Proposal: The applicant is requesting approval to partition a 0.63-acre parcel into two parcels of approximately 10,802 square feet and 16,605 square feet with access from a private easement along Old Salem Road.

PA 21-05 Vicinity

TENTATIVE PARTITION PLAT
SONA ATHWAL
4962 NE OLD SALEM RD.
ALBANY, OREGON

TO: Matt Straite, City Planner
FROM: Janelle Booth, Millersburg City Engineer
DATE: September 8, 2021
SUBJECT: PA 21-05 - Engineering Comments

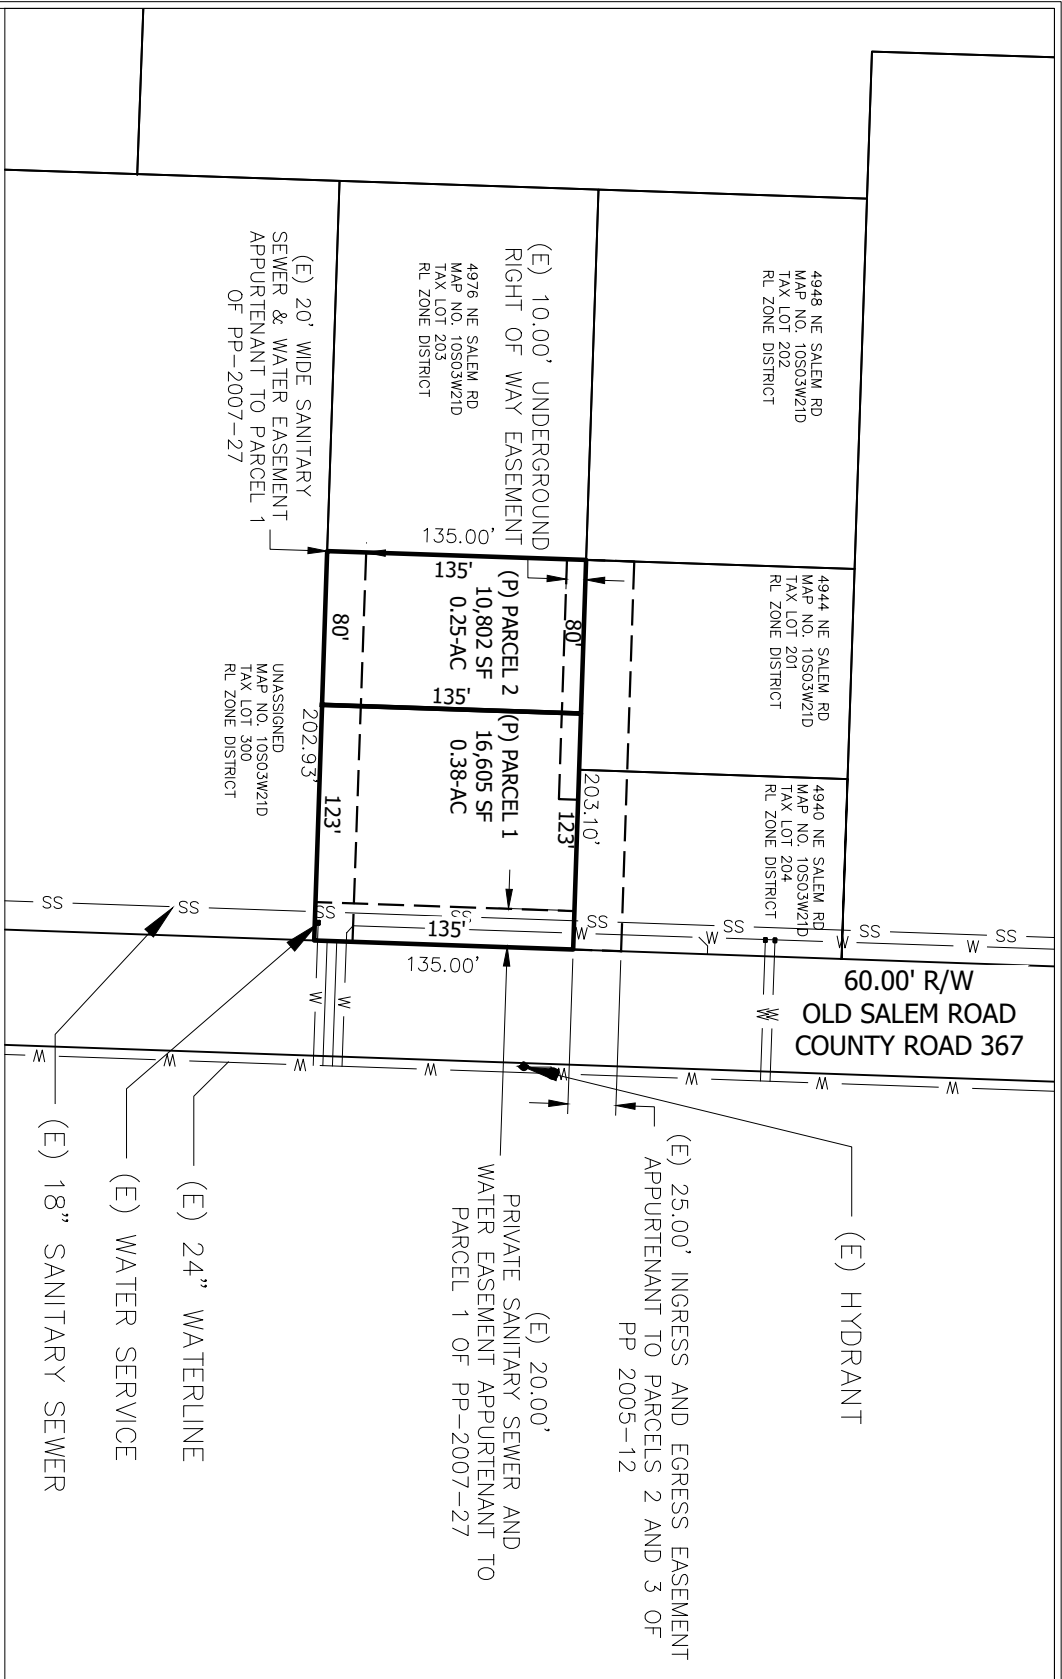
The application indicates that there is an existing gravel drive that presently provides access to four residences and one vacant lot. The gravel drive connects to Old Salem Road that is within Linn County Right of Way and under the jurisdiction of the Linn County Road Department. The vacant lot is proposed to be divided into two lots. This will bring the total number of lots and future residences to six (6).

The gravel road is only 10 feet wide and is within a 25 foot easement that is 203 feet long. The gravel road provides access to Old Salem Road as it crosses a concrete sidewalk.

- Provide a paved 22 foot wide paved road surface with a minimum paved surface thickness of 4 inches placed in 2- 2 inch lifts. In any case, the minimum length of the paved surface should be 100 feet. The paved road surface will require an adequate road base with four foot wide gravel shoulders or a sidewalk concrete surface.

- Reconstruct the sidewalk crossing at the entrance from Old Salem Road so it provides a minimum entrance width of 22 feet. The reconstructed sidewalk access will be required to meet ODOT's current ADA requirements.

- The gravel road outside the right of way is under the jurisdiction of the City. The city is encouraged to require a 50 foot minimum easement with a turnaround at the end of a

- Prior to the City approval of the final plat, the driveway shall be improved, to be at least 20 feet wide, and the access driveway for the section fronting the applicant's property shall feature paving at least 20 feet in width.

- Parcels shall take access through the existing shared driveway easement from Old Salem Road.
- The Old Salem Road access encroachment shall be extended to feature a 22-foot wide paved approach and sidewalk reconstruction to meet ADA. The existing 25-footwide ingress and egress easement must meet fire code and City of Millersburg requirements, including a 20 ft wide paved surface (asphalt or concrete) in accordance with Section 3.03.081 of the Millersburg Development Code. The driveway shall be paved for the entire length that is required for access to the two new homes that will be built on the proposed partition property (for both the shared driveway and the driveway in front of the garage doors).¹
